PCN# 20141212001
CC102x/CC1150 Orderable Part Number Retirement and Replacement

PCN Number:	20141212001			PCN Date:	12/16/2014							
Title:	CC102x/CC1150 Orderable Part Number Retirement and Replacement											
Customer Contact:	PCN Manager	Phone:	+1(214)480-6037	Dept:	Quality Services							
Last date to order:	06/16/2015		Last date to ship:	09/16/2015								
Change Type:	Orderable Part Number Retirement and Replacement											
Orderable Part Number Retirement and Replacement Notification Details												
Description of Part Number Retirement and Replacement:												
Texas Instruments, Incorporated (TI) is announcing the retirement of the CC102x/CC1150 Orderable Part Numbers. A lifetime buy is being offered with the dates given above. Replacement part numbers for these devices are shown in the Product Affected Section.												
Reason for Part Number Retirement and Replacement:												
The current CC1120, CC1121 and CC1150 orderable part numbers are changing due to moving assembly from an external sub-con into TI-CLARK which requires a change of package designator.

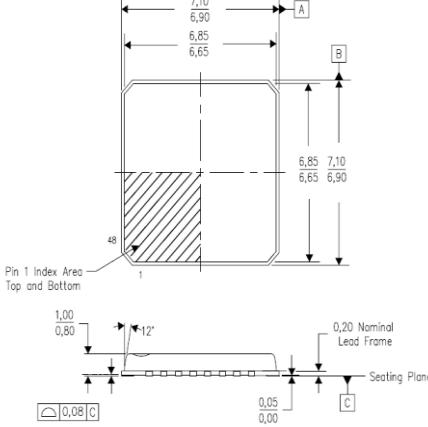
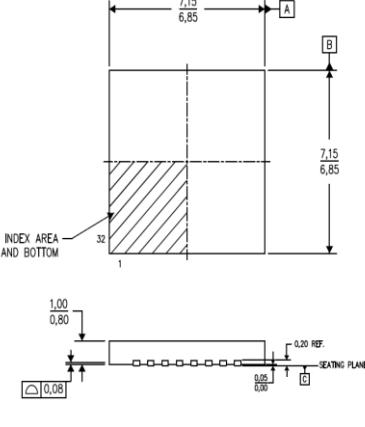
Note that the replacement product packages are saw singulated and are considered backwards compatible with the current punched packages, i.e. no PCB footprint change is necessary. Packing materials (shipping boxes, tape & reels, etc.) at the additional site will be consistent with materials currently in use at the current site.

Note also that the material sets of the replacement products are changing per the below:

Current	New
Assembly Site	SCSAT	TI Clark
Mount Compound	R008-0097X	4207123
Mold Compound	R003-0301X	4208625
Bond Wire Type	Au	Cu, Au
	Punch	Saw
Package Singulation
